Re: Semi-Annual Report Uranerz Energy Corporation Nichols Ranch ISR Project, SUA-1597

Revised pages to the license application are enclosed in accordance with SUA-1597 License Condition 9.4E. An index of change has been included to guide insertion into the license application.

**Nichols Ranch ISR Project
License Number SUA-1597
Docket No.40-9067**

Semi-Annual Report

FIGURE 5-1 URANERZ ORGANIZATION

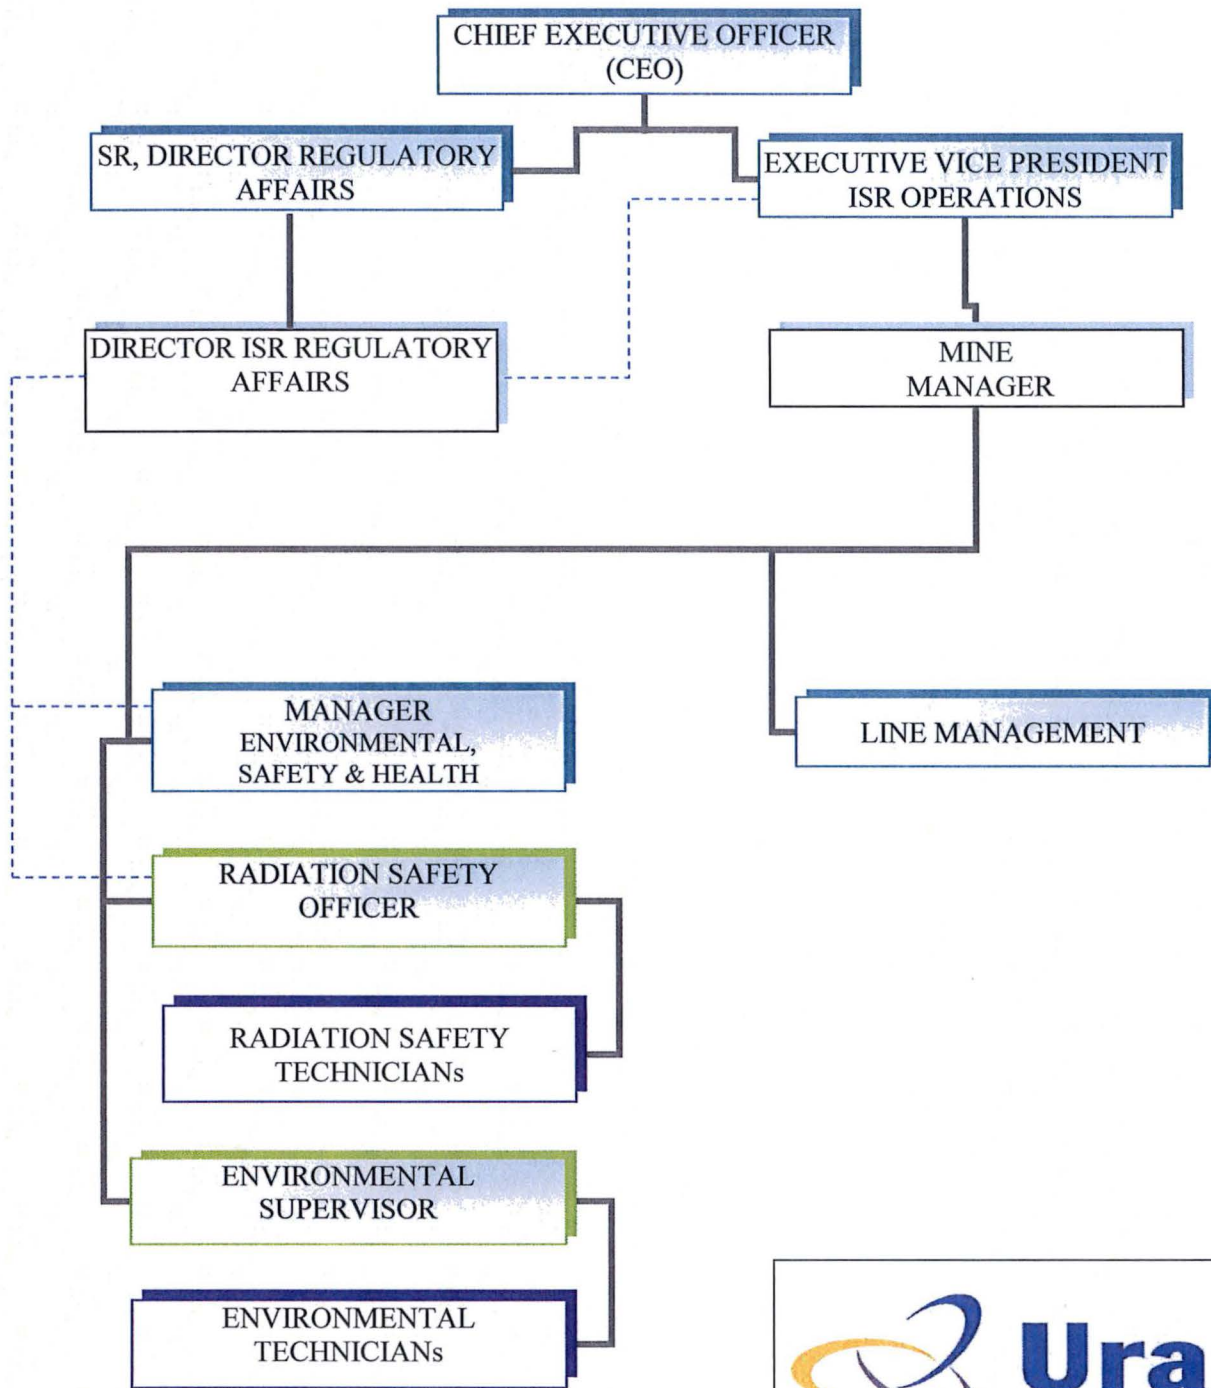
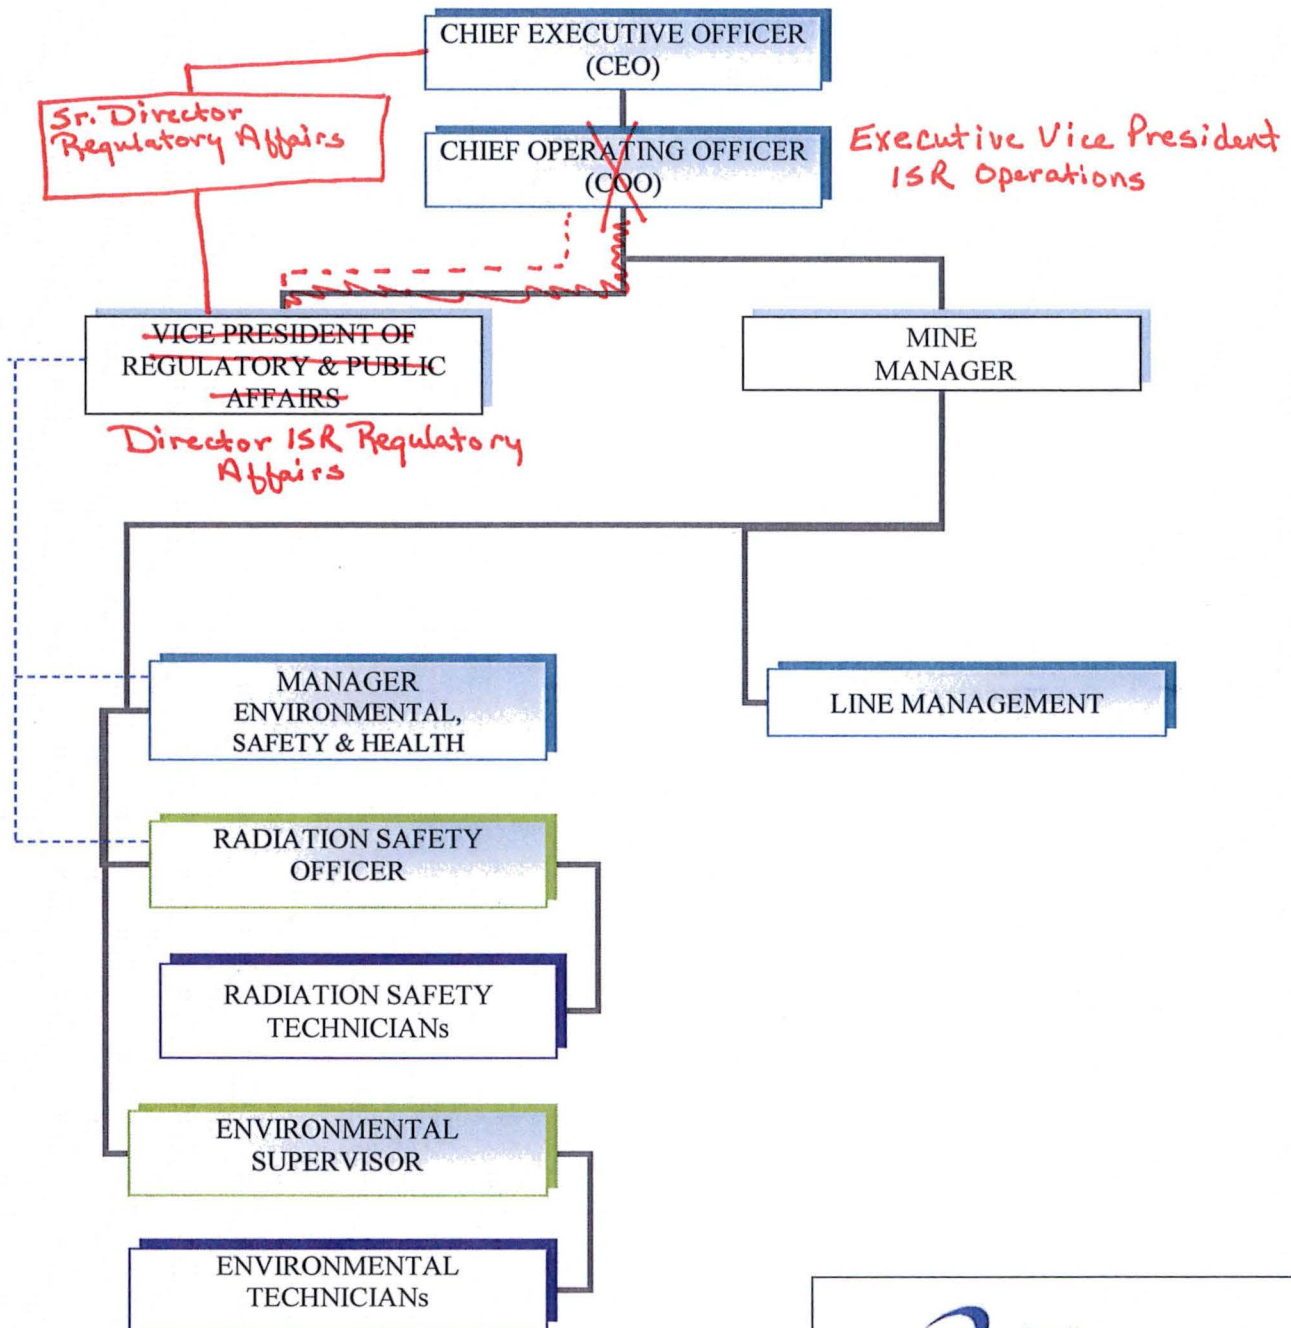
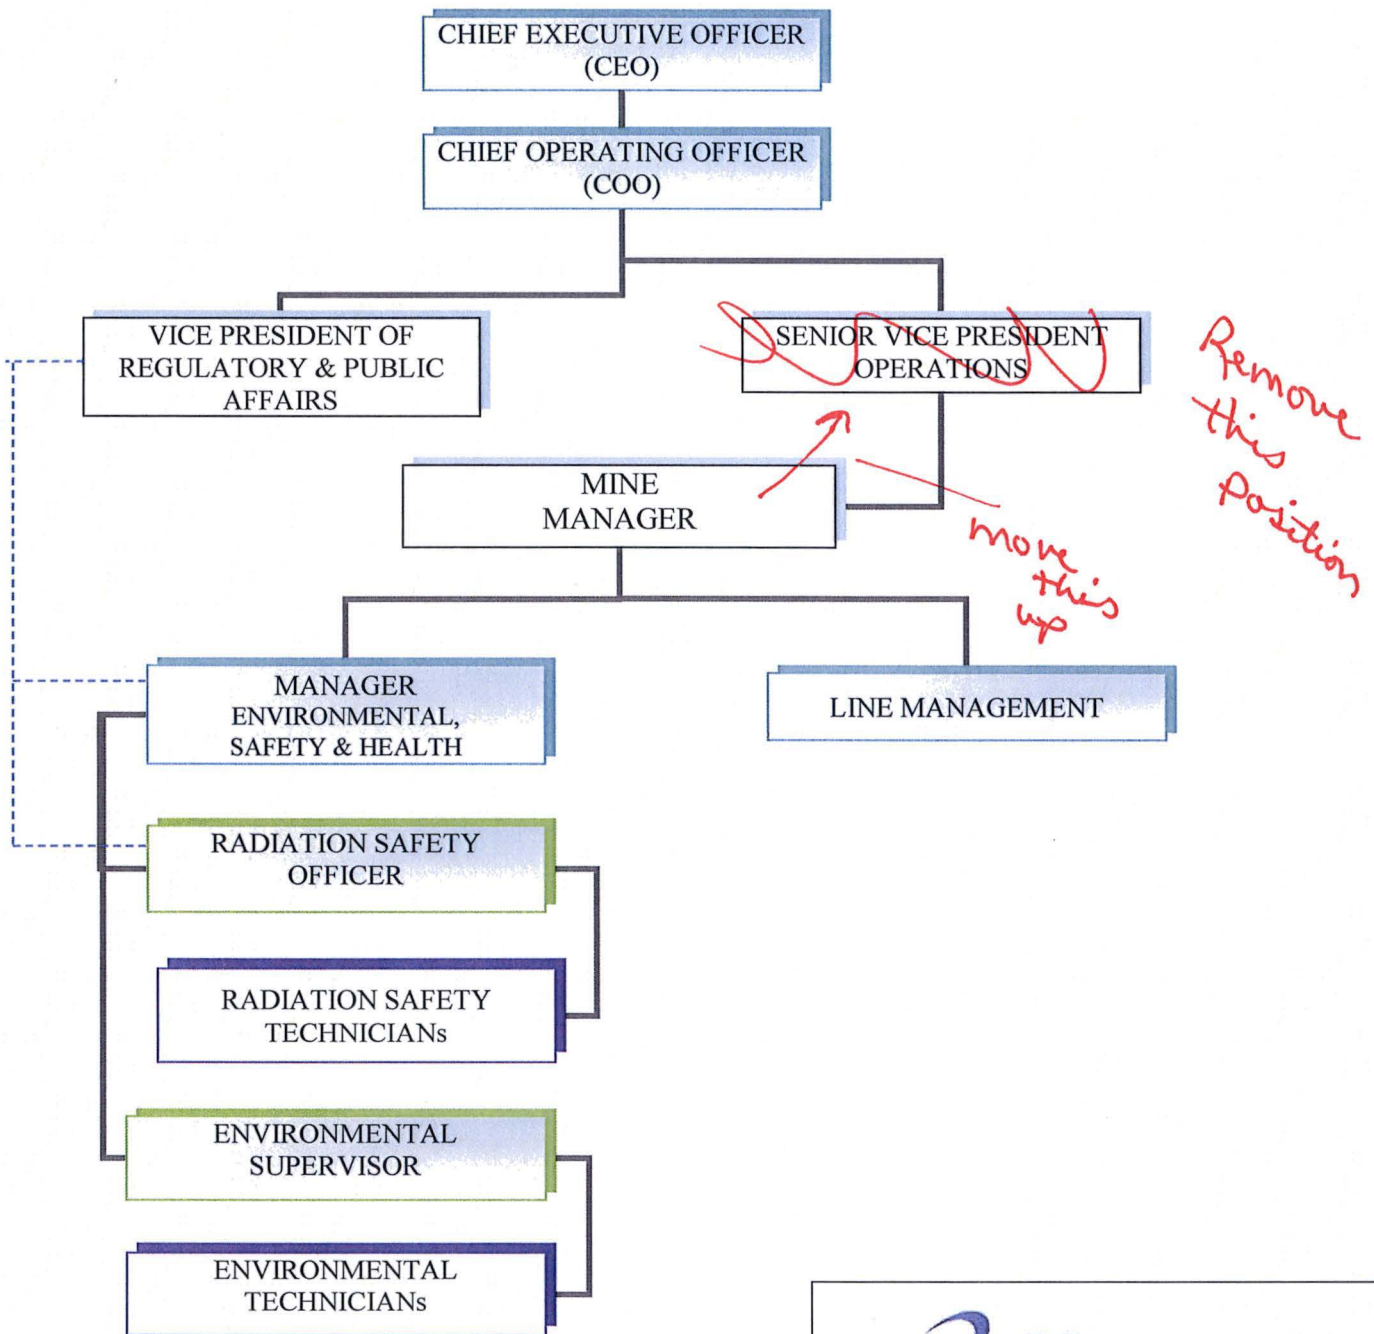
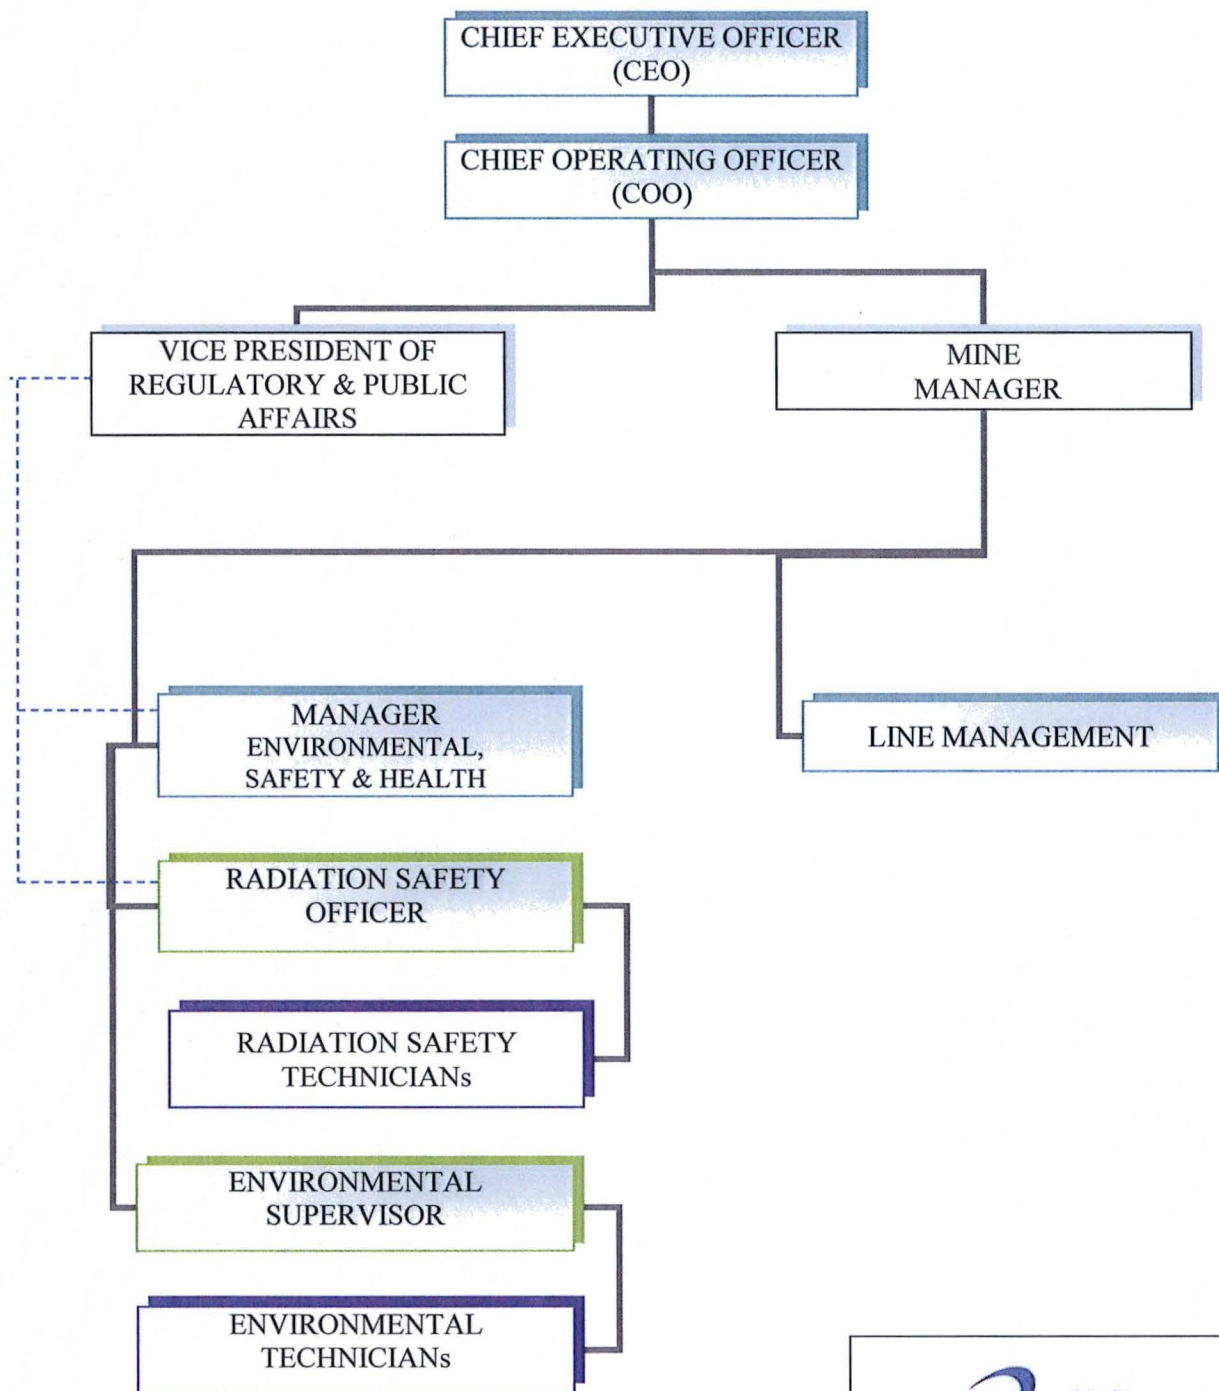
~~The Senior Vice President, Operations reports directly to the COO. The Senior Vice President, Operations is responsible for all production activity at the site. In addition to production activities, the Senior Vice President, Operations is also responsible for implementation of industrial and radiation safety, and environmental protection programs associated with operations. The Senior Vice President, Operations directly supervises the Mine Manager.~~

The Mine Manager reports directly to the ~~Senior Vice President, Operations~~ COO. All site operations, maintenance, construction, environmental health and safety, and support groups report to the Mine Manager. The Mine Manager is authorized to implement immediately any action to correct or prevent hazards. The Mine Manager has the responsibility and the authority to suspend, postpone, or modify, immediately if necessary, any activity that is determined to be a threat to employee or public health, the environment, or potentially a violation of state or federal regulations.

The Mine Manager reports directly to the ~~COO~~ EVP. All site operations, maintenance, construction, environmental health and safety, and support groups report to the Mine Manager. The Mine Manager is authorized to implement immediately any action to correct or prevent hazards. The Mine Manager has the responsibility and the authority to suspend, postpone, or modify, immediately if necessary, any activity that is determined to be a threat to employee or public health, the environment, or potentially a violation of state or federal regulations.
